# Planning & Zoning Commission

June 30, 2008 Meeting

**SUBJECT:** Consider approval of PZ Case 08-30 Site Plan amendment to Dairy Queen at 6150 Merle Hay Road.

1 Front Elevation - Base Level  
Scale: 1/4" = 1'-0"

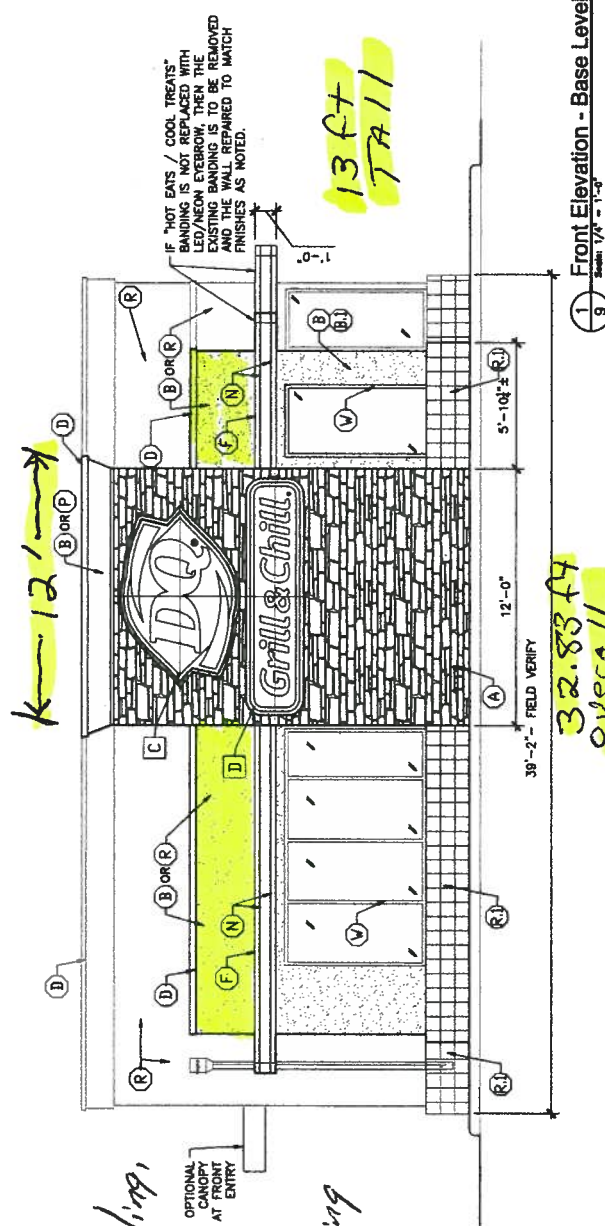
Changes to the east elevation facing Merle Hay road include the installation of the same metal panel above the existing black awning and the addition of a 12’ wide by 13’ tall brick chimney. The original proposal detailed the use of simulated stone to construct the chimney; however, the use of stone does not satisfy code requirements which mandate at least 50% of the wall area facing Merle Hay Road be constructed of brick. The applicant subsequently altered the choice of building materials and submitted a brick sample to comply with code requirements. The resultant percentage of brick facing Merle Hay is approximately 70%.

Brick chimney will stop at top of building

The Hi-lited cornice we raise 12" above the front of the Building

Chimney will stop at top of Building

3. Non-residential buildings abutting Merle Hay Road shall have brick constitute at least 50% of the wall area that faces the street (excluding glass). The use of stone may or may not present an issue, depending upon the percentages.

1. Site Plan. There are no changes to be made to the overall site plan as it was submitted when the original construction took place. The changes to be made are cosmetic to the outside of the building only.
2. The front of the building as illustrated on page 2 of this package is 32.83 ft across and 13.1 ft tall. The brick chimney will be 12ft wide and 13 ft tall which upon completion will take up 39.4% of the front of the building. Also please note that the architectural steel panels above the black awning will be 33inches tall and will go across the upper part of the building with the exception of the brick chimney area. This will result in a coverage area by those panels of 14% of the total front of the store.

1 Right Elevation - Base Level  
Scale: 1/4" = 1'-0"

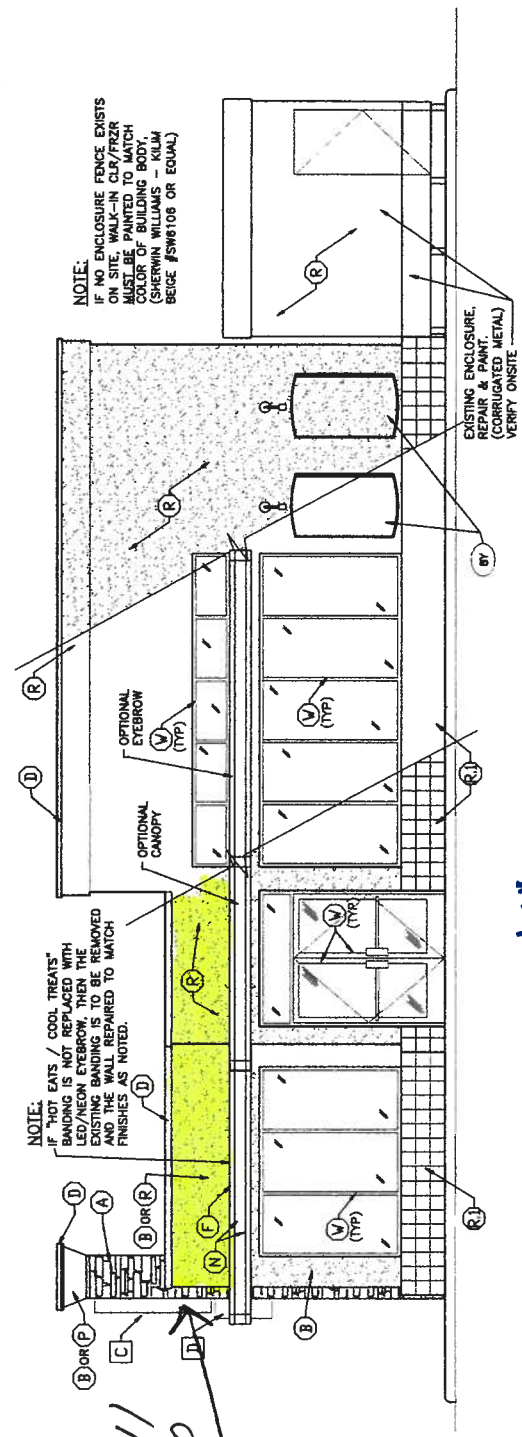
Changes to the north and south elevations entail installation of a 33” metal wall panel above the existing black awning. This metal panel will extend approximately 27’ or nearly half the depth of the building.

*These panels  
on top of  
Black Edge  
on front of  
Lower part  
of Building  
only*

These architectural panels will also continue down the side of the building as Highlighted only on the lower portion of the building. Remaining at 32" tall and Going 28ft and ending where the higher portion of the building begins.

**I FULL HEIGHT CHIMNEY**  
 (Base-Level Remodel)

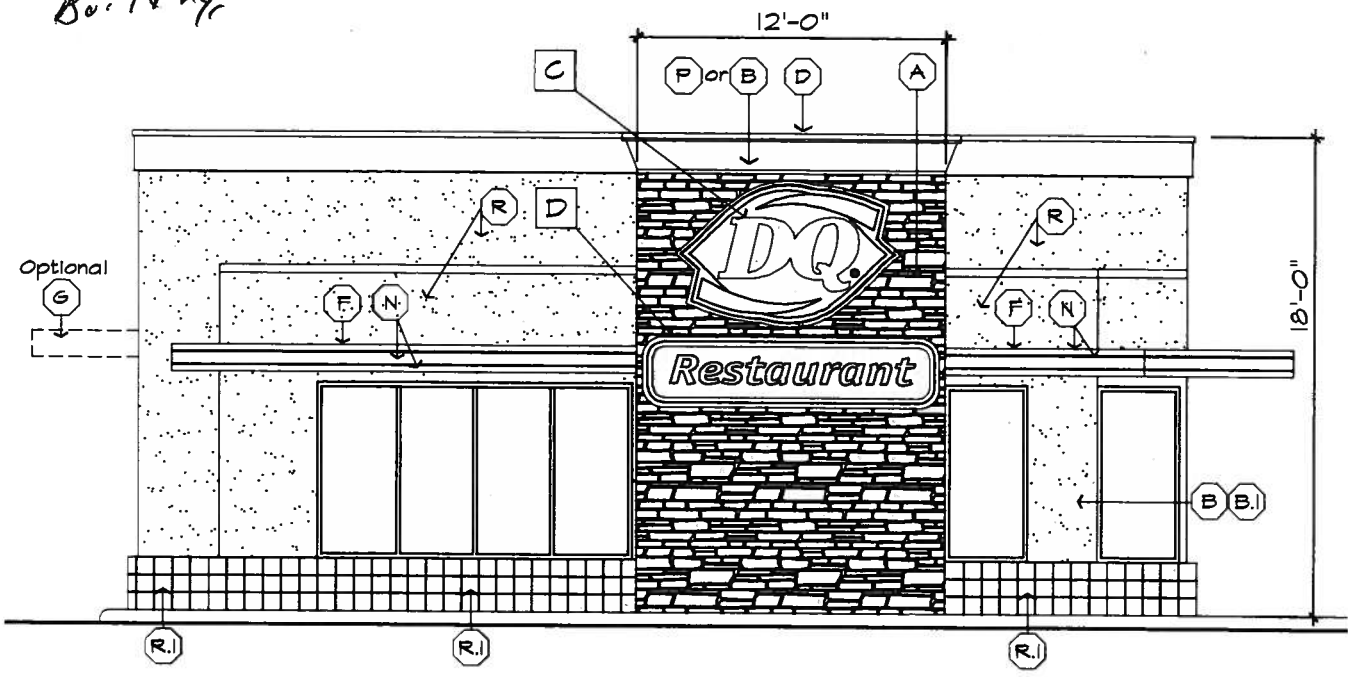
① Front of Existing Building is 13'  
 ② Area 0 or chimney cap will be 12" above Building  
 ③ Chimney covered in Ledgestone  
 ④ Would like to come out as far as possible from Building without a footing, or will stay flush with Building
